Re: Site Closure Report

re: Harbert Transportation, 19984 Meekland Avenue, Hayward, California

2.0 RESPONSE TO TECHNICAL COMMENTS

Figure 8
MW-5: BENZENE Concentrations from 1990-2005
 (MW-5, On-site, immediately adjacent to source -- former UST excavation)

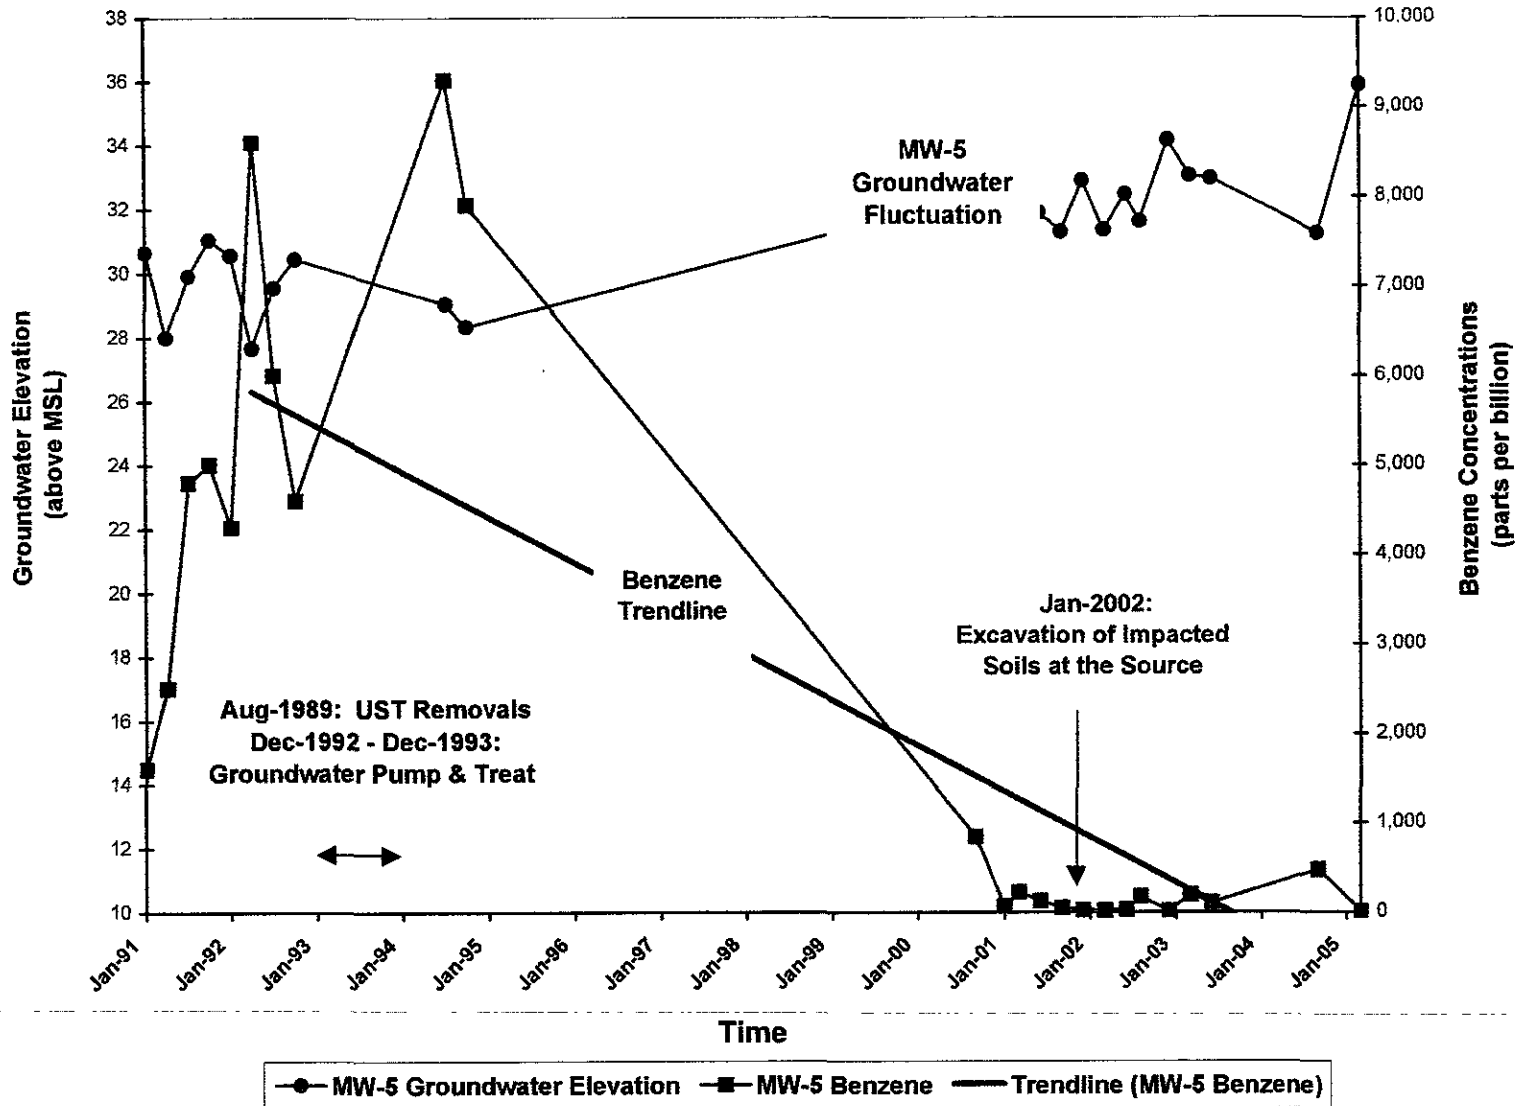
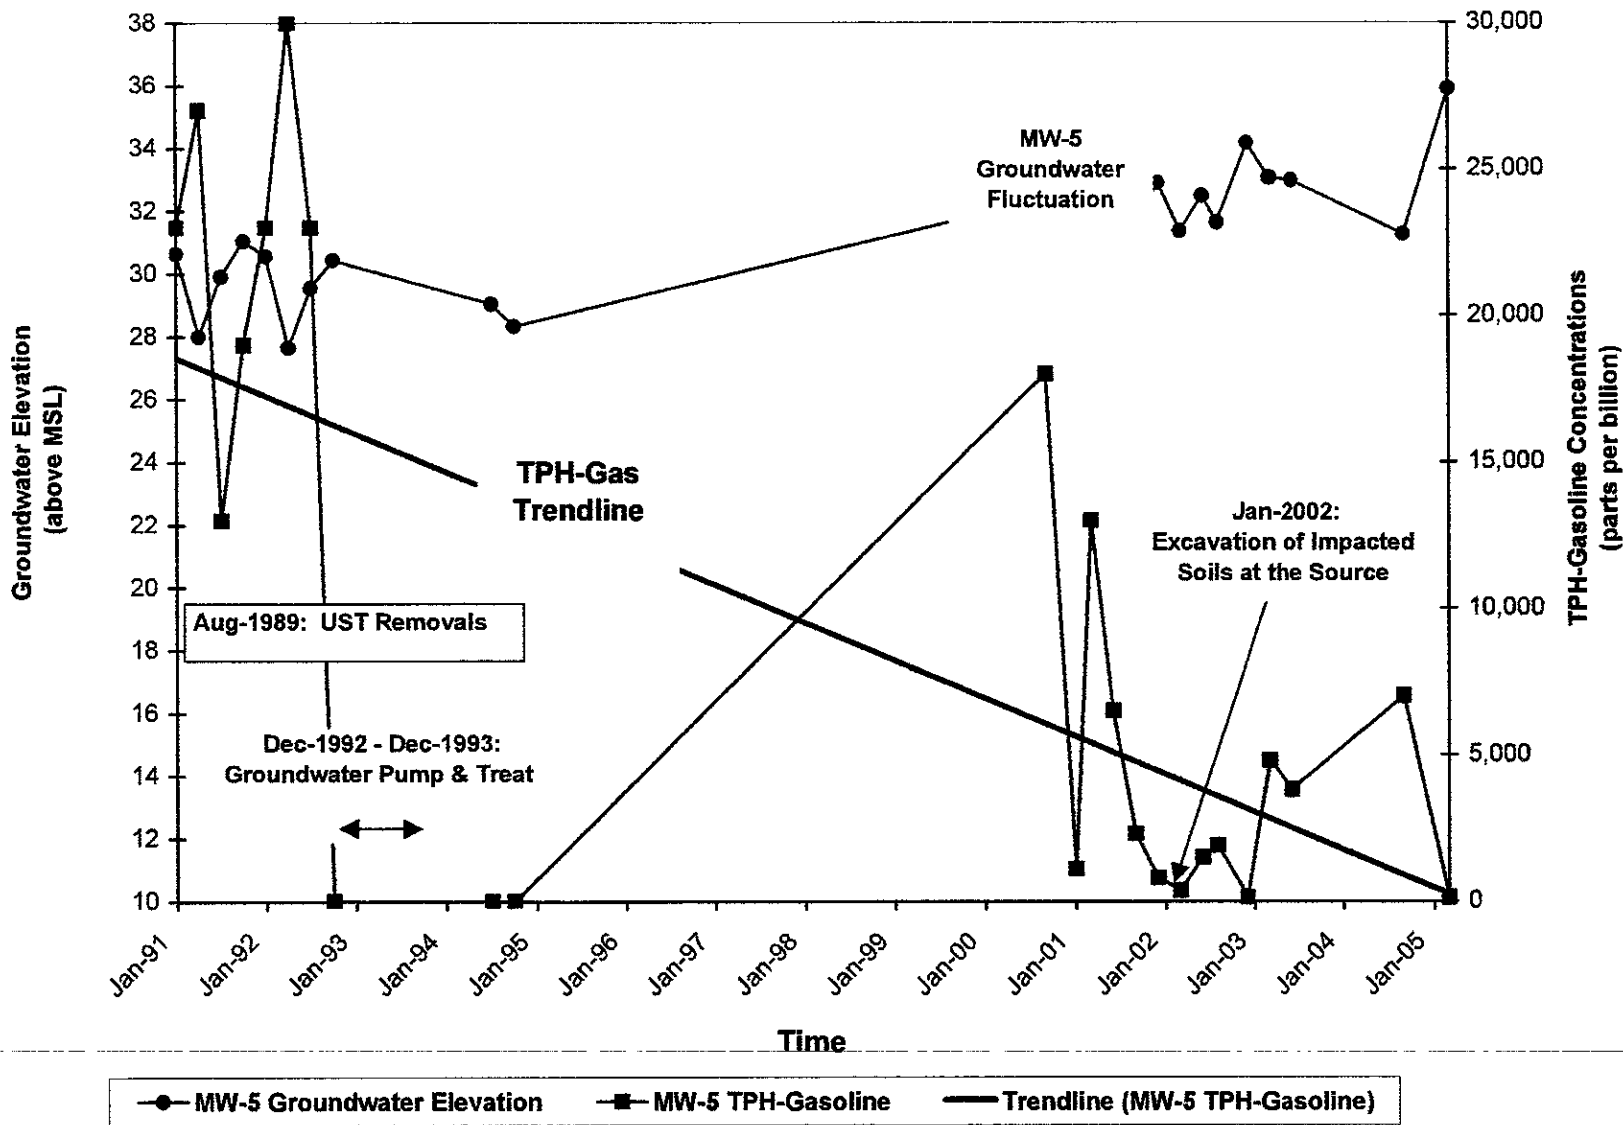
Weber, Hayes *Workplan Addendum* Figures 10 and 11 show that TPHg and benzene concentrations were decreased between approximately December 2000 and July 2003. Since mid-2003, both benzene and TPHg concentrations in well MW-5 have increased. It also appears that groundwater elevation at the site was generally higher between December 2000 and July 2003. From July 2003 to September 2004, water levels dropped approximately 2 ft in wells MW-5 and MW-9. Since benzene and TPHg concentrations in source area well MW-5 are currently at their highest levels in 2 years, additional evaluation is required. As discussed below, pre- and post-remediation data should not be mixed; time series plots of groundwater concentrations should include post-remedial concentrations only. We request that you evaluate the potential for groundwater concentrations to continue to rise as water levels drop. Please submit your analysis in the report requested below.

#4 Response: This comment indicating there are high concentrations at MW-5 predates the most recent groundwater sampling. Dissolved hydrocarbon concentrations at MW-5 were very low in 2004 (see Table 1) and now are below Cleanup Goals/Water Quality Objectives. Recent sampling of all 10 groundwater monitoring wells at the site (WHA April 11, 2005), show significant further decline in the already low residual dissolved hydrocarbon concentrations. This recent sampling demonstrates that hydrocarbon concentrations are now **below** the Cleanup Levels proposed by ACEH, in all wells, for all constituents except one (TPH-gas was detected in MW-9 at 1,100 ug/l., versus a Cleanup Goal of 1,000 ug/L).

To emphasize the clear long term downward trend of hydrocarbon concentrations is not just a recent sampling event due to water level, WHA prepared six figures (Figures 8-13), showing Benzene and TPH-Gas trends (with groundwater elevations) over time in well MW-5 (located at the source), MW-9 (located at the property line) and MW-10 (downgradient, across the street). These time series plots were designed to show data throughout the pre- and post remediation timeline. The entire timeline was graphed to show the steady decline in hydrocarbons, which appears to be due in part to remedial action and significantly to natural attenuation. In WHA's opinion showing only post remediation data, would not be as instructive or as complete of a record. Nonetheless, to accommodate the ACEH comment all figures clearly delineate pre and post remedial action data thereby allowing any future reader easy access to all relevant information. The most recent drop in hydrocarbons coincided with a normal seasonal rise in groundwater levels. The data for all three wells shows:

Figure 10
MW-9: BENZENE Concentrations from 1991-2005
 (MW-9, On-site near downgradient property line)

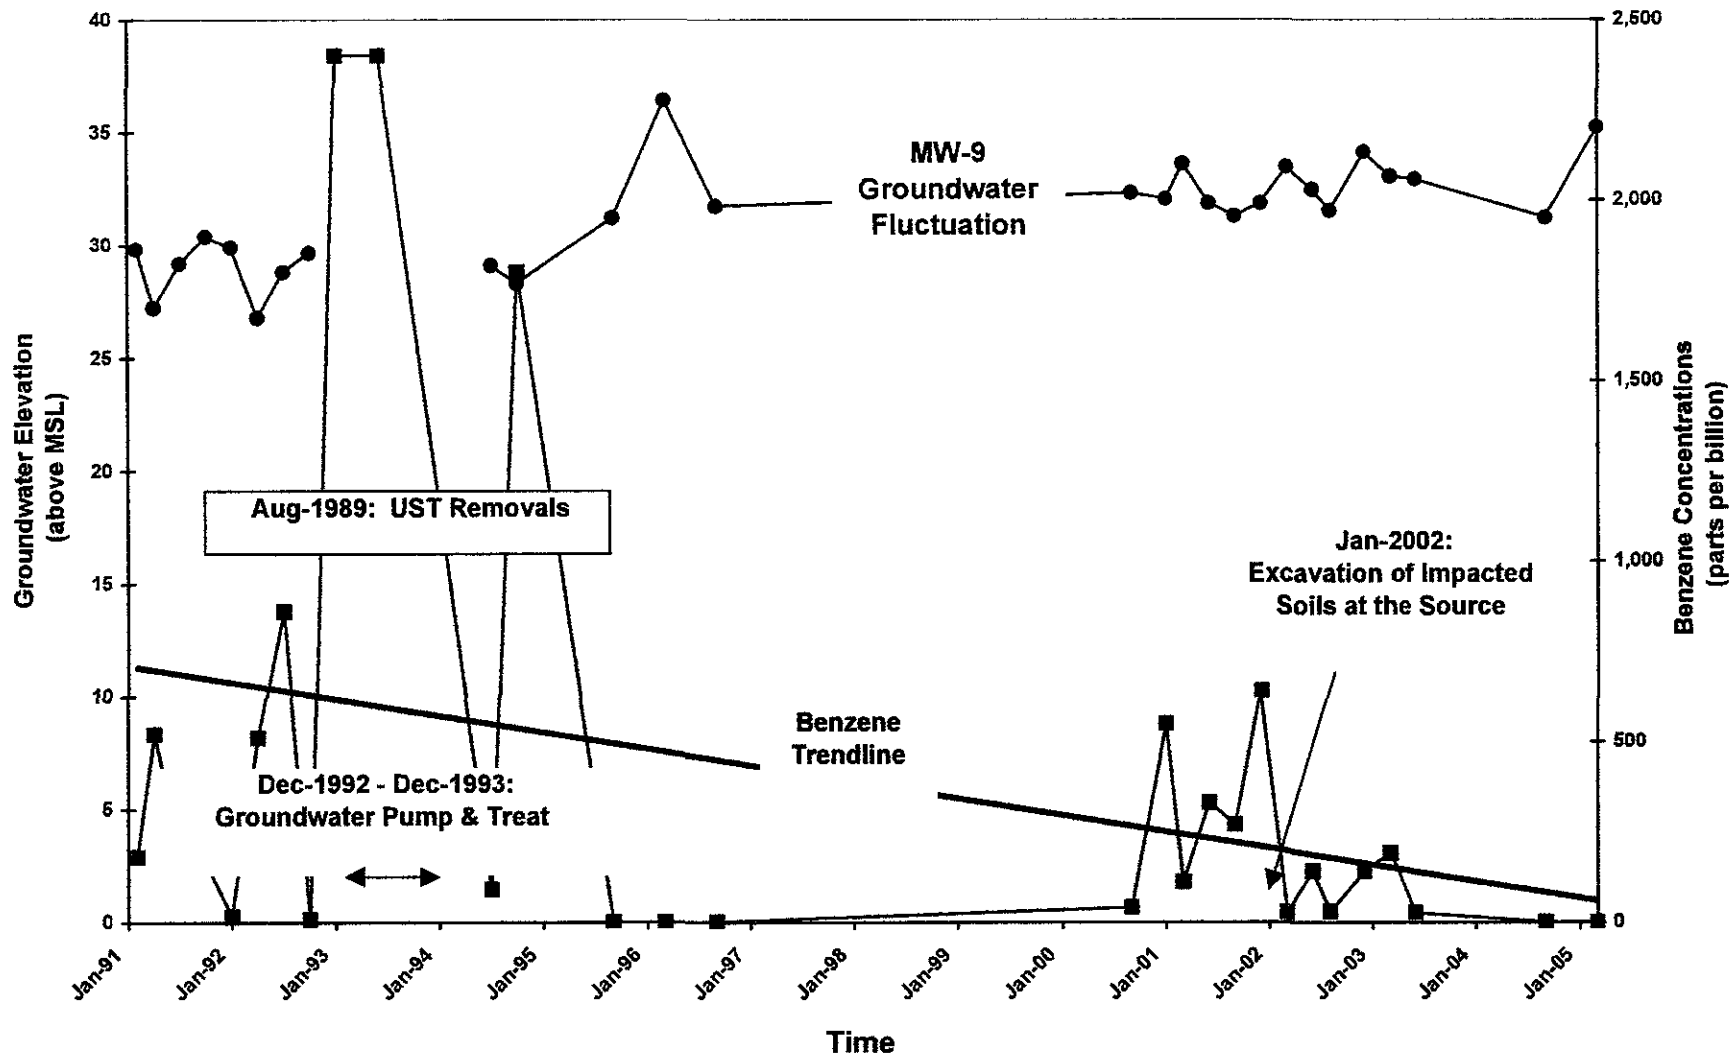
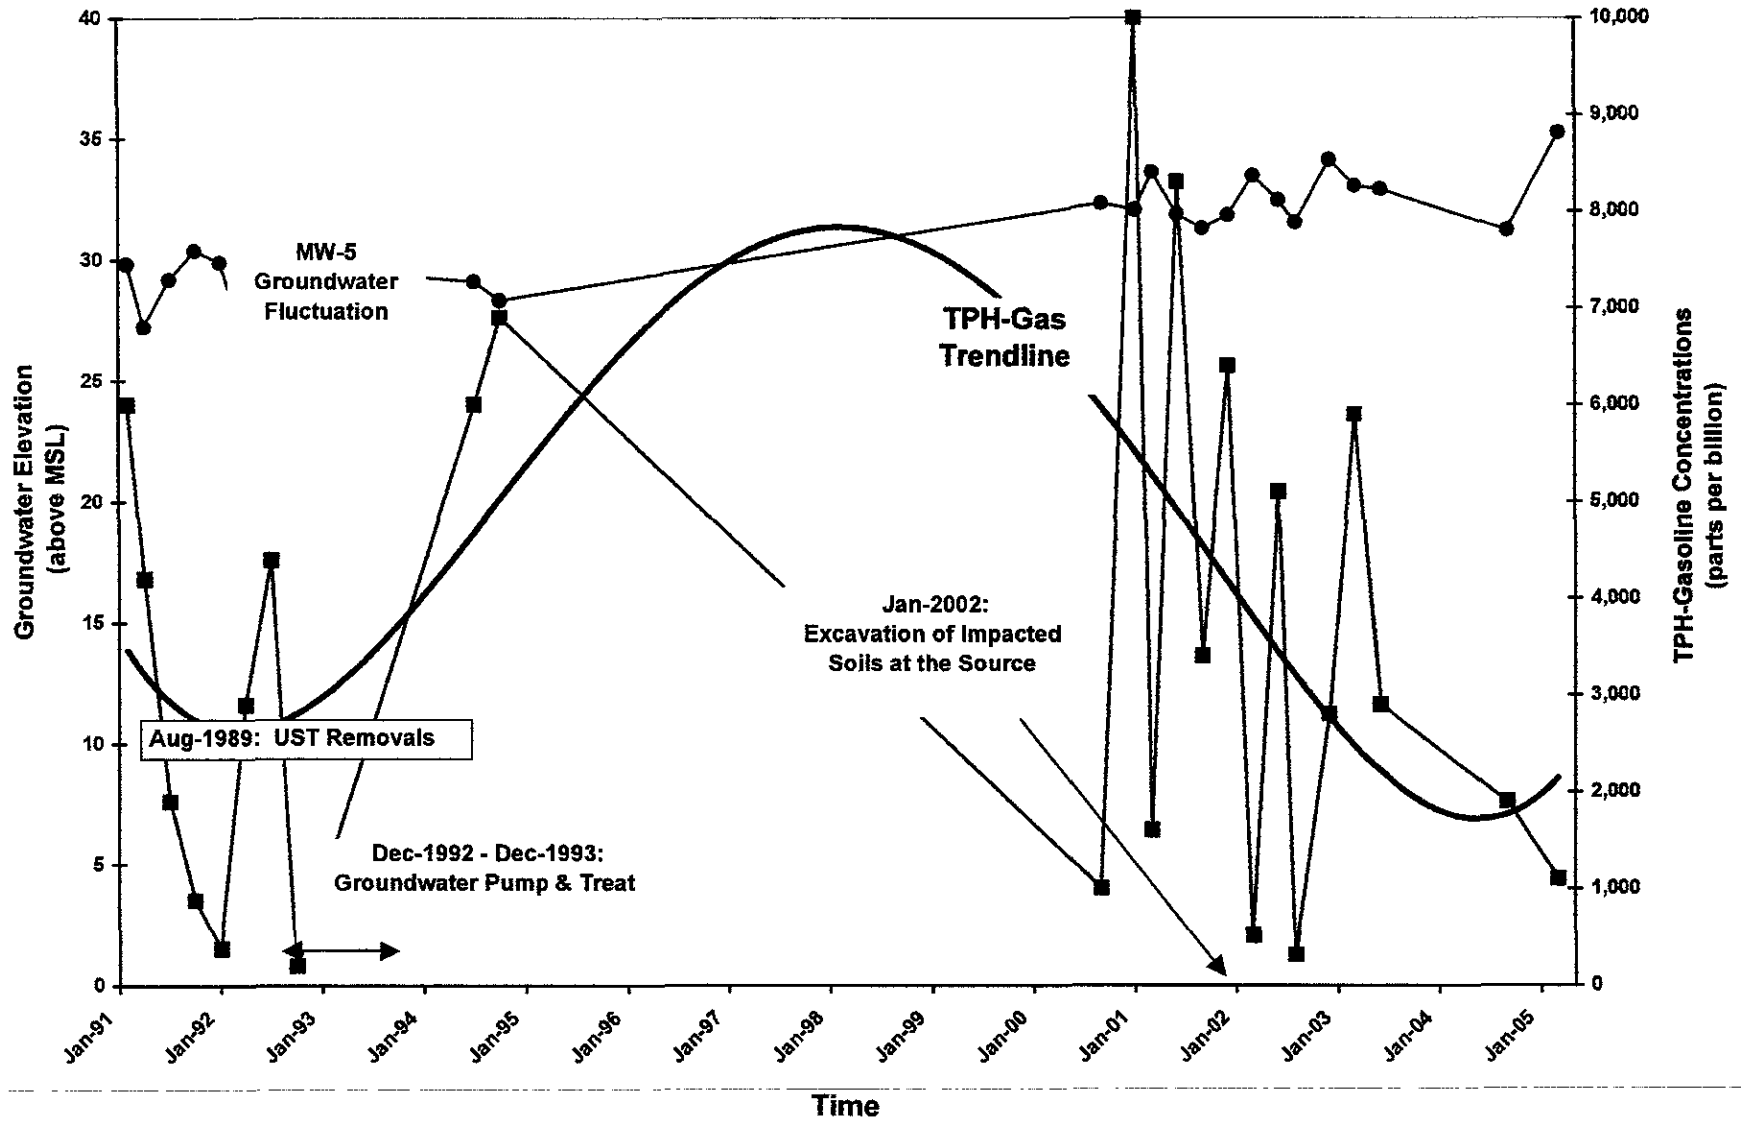
B) Reliability of Existing Monitoring Points: *"Please evaluate the screening of well MW-9 and other key wells in your monitoring network. In the report requested below, please further support your argument that no additional downgradient sampling should be required, or if necessary, propose additional sampling prior to implementing your workplan".*

#2B Response: Monitoring well MW-9, located at the downgradient property line, is screened from 20-40 feet deep, with depth to water typically at about 24 feet. The geologic log for MW-9 shows it to be screened in silty clays to clays, logged as "moist" (Appendix B, WHA January 27, 2005). This well is screened in the first saturated zone, is located approximately 60 feet downgradient from the former UST pit, and is a highly suitable groundwater monitoring point, as indicated by its high concentrations of benzene and TPH-gas prior to 1995. The trendline of hydrocarbon concentrations in MW-9 shows a consistent decline over time and current TPH-gas and benzene concentrations exist at 1,100 parts per billion (ppb) and not-detect (<1), respectively (see Figures 10 and 11, *TPH-gas and Benzene in MW-9 versus Time*).
